1606 California Ave. SW

DPD Project #3016112

Design Review Recommendation Meeting

Response to EDG Recommendations

Garage Plan

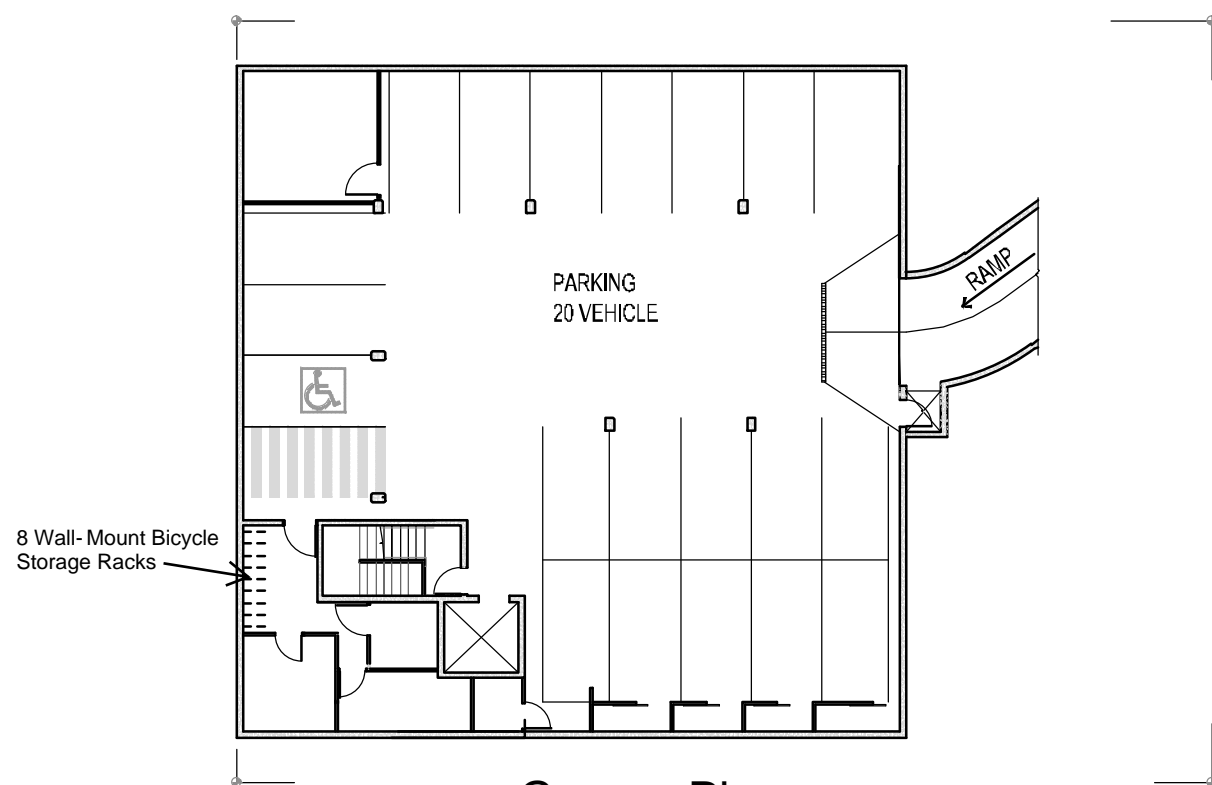
- a) The Board noted the current parking ramp begins at the low point of the site but felt the ramp location adjacent to the sidewalk provided a potential safety hazard. At the Recommendation Meeting the Board would like to see an analysis of a different access location further south on the alley and an analysis justifying proposed access point (DC1-B Vehicular Access and Circulation, DC1-C Parking and Service Uses). **The driveway entrance has been moved as far south down the alley as possible without having to eliminate unit floor area.**

- b) The Board recommended moving the building to 5' feet to the California Avenue SW property line would help resolve additional ramping needs for an alternative access location. The Board also was willing to review a design departure for a steeper ramp as necessary to facilitate a different access location on the alley (DC1-B Vehicular Access and Circulation). **A departure request has been made to have some of the ramp at 20% grade. The overall grade, including crest and sag slopes, is 17.3%. See p. 21 of the DR packet.**

1. EXCEED THE MAX. ALLOWED RAMP SLOPE PER SEC. 23.54.030 D.3.
 - A. SLOPE ALLOWED: NO PORTION OF RAMP SHALL EXCEED 15%
 - B. SLOPE PROPOSED: PROPOSED DRIVEWAY SLOPE IS 20%. THE OVERALL SLOPE, INCLUDING CREST & SAG, IS 17.3%

- C. JUSTIFICATION: THE DRIVEWAY WAS MOVED FROM THE NORTH PROPERTY LINE, ADJACENT TO THE SIDEWALK, SOUTHWARD. THIS MOVE WAS TO INCREASE SAFETY FOR PEDESTRIANS BY PREVENTING POTENTIAL CONFLICTS BETWEEN PEDESTRIANS & AUTOS AT THE INTERSECTION OF THE ALLEY AND SIDEWALK. MOVING THE DRIVEWAY FURTHER SOUTH AWAY FROM THE SIDEWALK INCREASES THE HEIGHT OF THE RAMP MUST SLOPE DUE TO RISING ALLEY GRADE.

THE "BEACON" OPTIONS

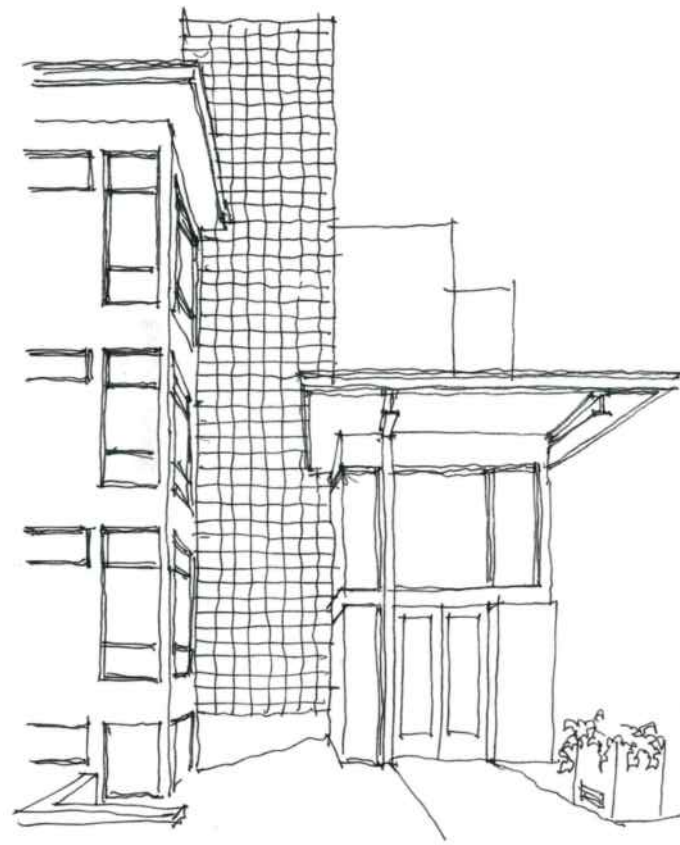
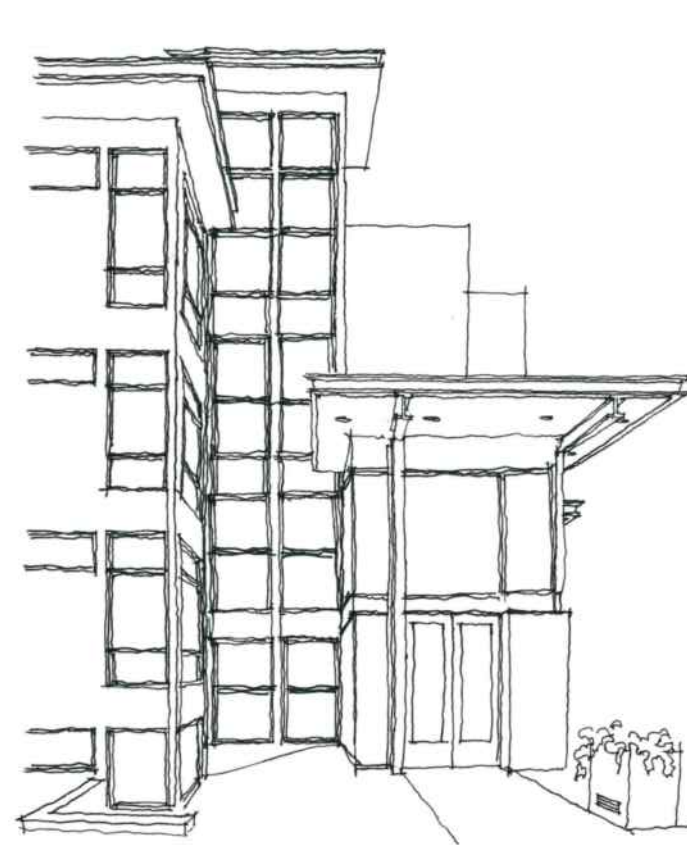
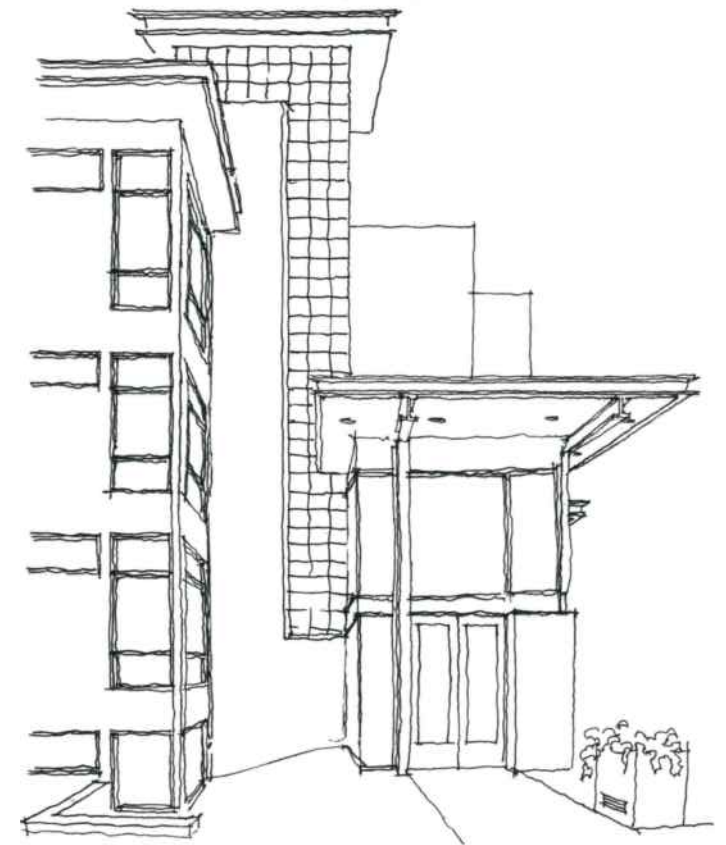
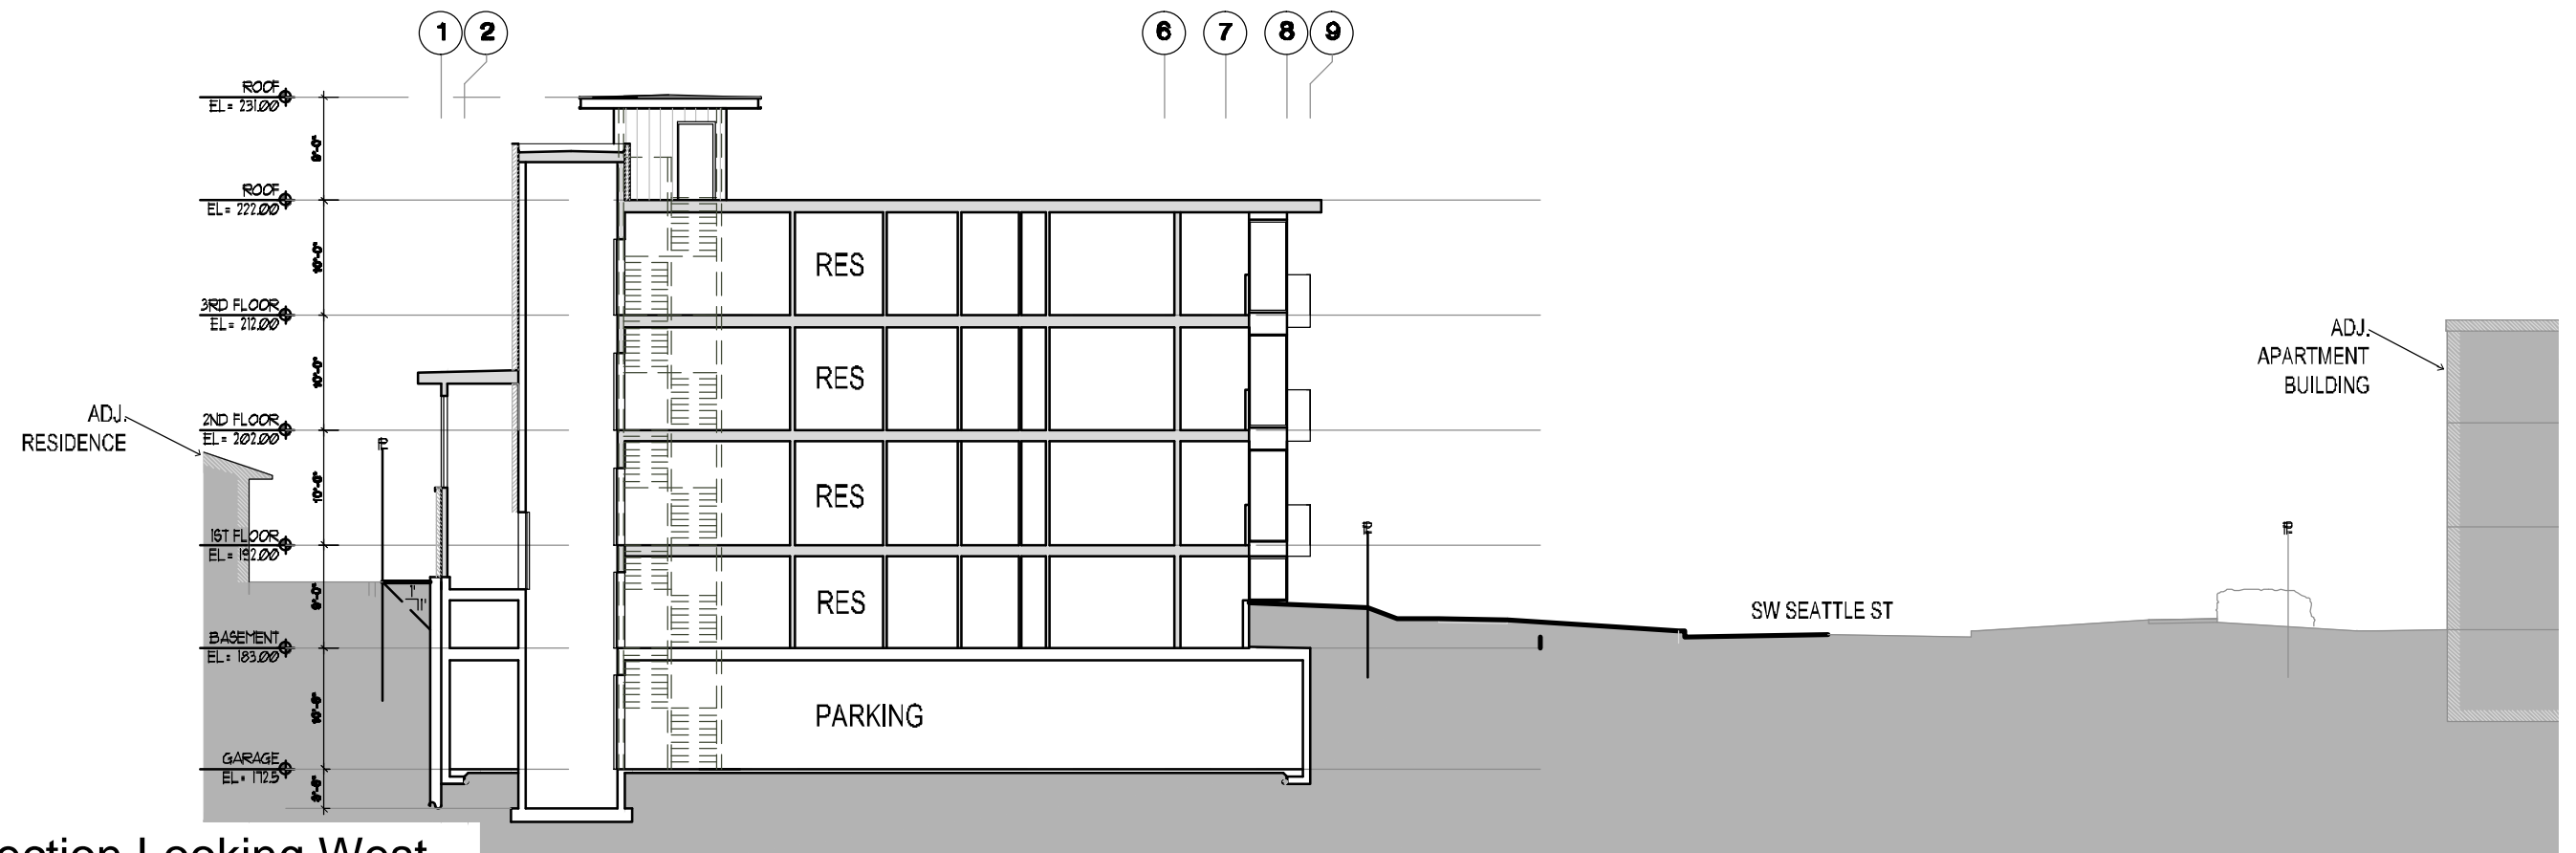
- d) The Board felt the entrance lobby lighting should act as a beacon for residents and visitors to the site. The Board requested a full lighting plan at the recommendation meeting (DC4-C Lighting). **The “beacon” tower feature of up lit glazing provides an identifiable building entry. Building lights (including the stair/entry “beacon”) and pathway lighting provide nighttime security. Up lights located at the entry provide reflected light off roof overhangs. Ground level up lights at trees near the alley provide additional reflected light. See p. 20 of the DR packet for the Exterior Lighting Plan.**
